Bhutan Power Corporation Limited
InfoComm Services Division
Thimphu : Bhutan

Reference : Bid no: BPC/ICSD/SDH-1/2K9- Supply, installation & commissioning of SDH equipment for establishing international gateway and nodal bandwidth distribution points.

Subject : Amendment 1 to the referred Tender

AMENDMENT No. 1

Figure 1.1 – SDH NETWORK DIAGRAM (Amended)

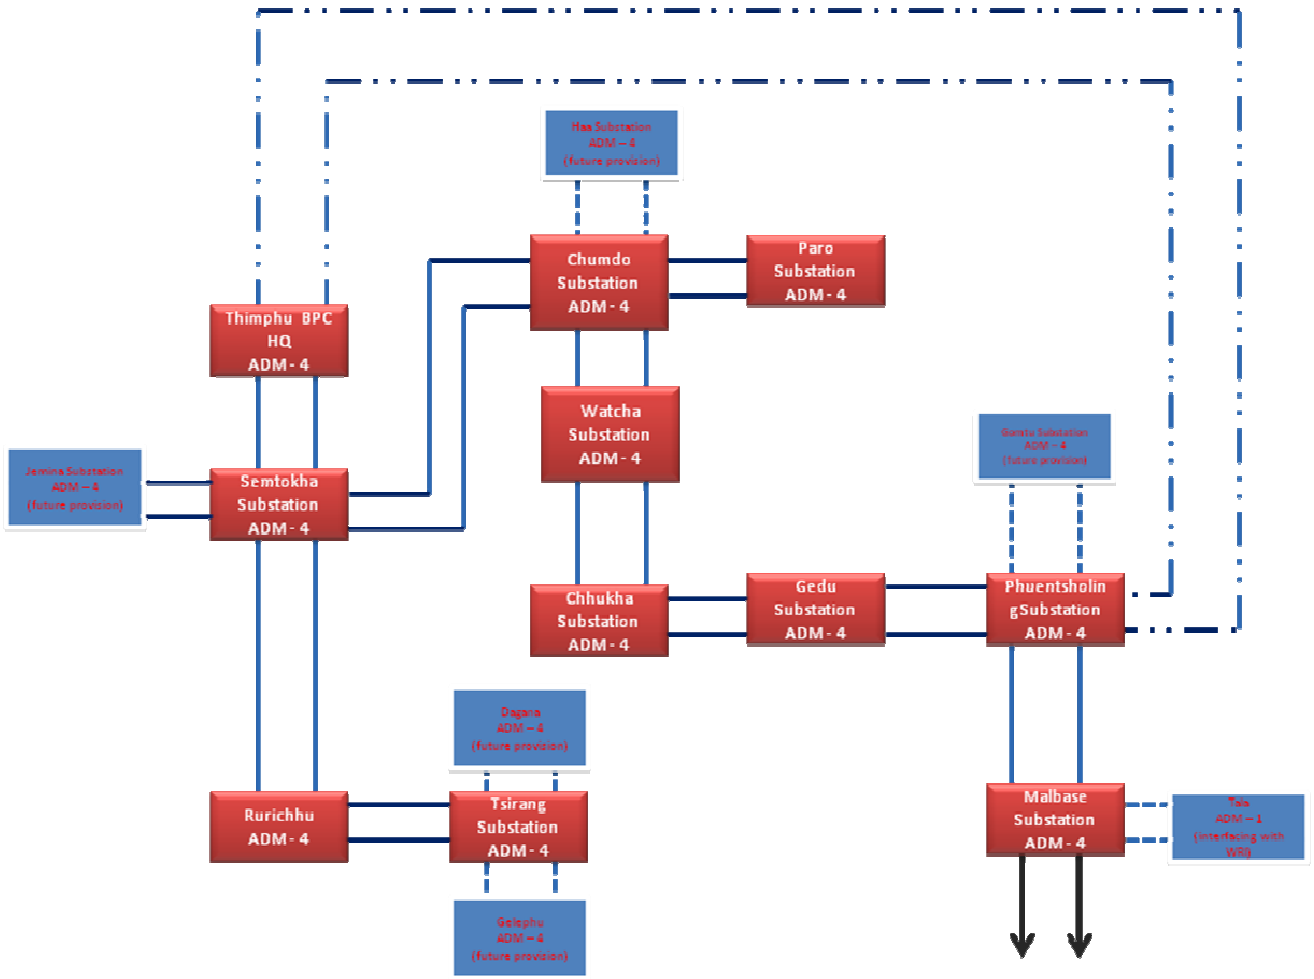
1. SDH network Diagram (Figure 1.1)

The SDH Network diagram (Figure 1.1) has been revised to bring more clarity on the connection details and BPC's own requirements. Actual site conditions will determine the final connectivity which is not expected to deviate too much from the amended SDH network diagram. The amended network diagram is given below:

The revised SDH Network diagram shows the intended connectivity among various en-route substations between Phuentsholing and Thimphu and a separate direct connection between Phuentsholing and Thimphu. It may be noted that the transmission line route with OPGW (24-fibre) connectivity is same and the intent is to route 2 fibres via all intermediate substations, while 2 fibres are intended to be used for direct connection between Thimphu and Phuentsholing. Bidders are advised to note that for the direct interconnection, amplification if

any, due to long distance between these two terminal stations, shall be achieved by utilizing the equipment being supplied at one of the intermediary stations. Such arrangement will be part of the scope of this work and should not result in any additional cost implications to BPC.

2.	Equipment at Semtokha site: The site has been excluded from the list of distances. Request you to confirm the requirement of equipment at Semtokha site and the pertaining distances.	A STM-4 upgradable to STM 16 is to be installed at Semtokha too. Refer revised Table 1.1 & Fig. 1.1of the amendment document for revised distances and network diagram.

2.	Please clarify the distance of the following station: Chumdo Substation to Chhukha Substation Thimphu BPC HQ to Semtokha Substation Semtokha Substation to Rurichhu Chumdo Substation to Semtokha Substation	Refer revised Table 1.1 & Fig. 1.1of the amendment document for revised distances and network diagram.

6.	Optical fiber lengths to and from Semtokha are not specified in the tender	Refer revised Table 1.1 & Fig. 1.1of the amendment document for revised distances and network diagram.

7.	With reference to SDH network diagram (figure 1.1 of tender) and optical fiber length table (table 1.1) need more clarification on how Chumdo is connected to Thimphu.	Refer revised Table 1.1 & Fig. 1.1of the amendment document for revised distances and network diagram. . Thimphu is connected to Chumdo via Semtokha.

8.	SDH network diagram shows Malbase is connected directly to Siliguri (India) whereas optical fiber length table shows Malbase is connected to Bhutan India Border need more clarification here.	The distance between Malbase and Siliguri is about 140 Kms and the distance from Malbase to the Bhutan India border is about 28 Kms, so 112 Kms of the distance between Siliguri and Malbase lies on the India side.
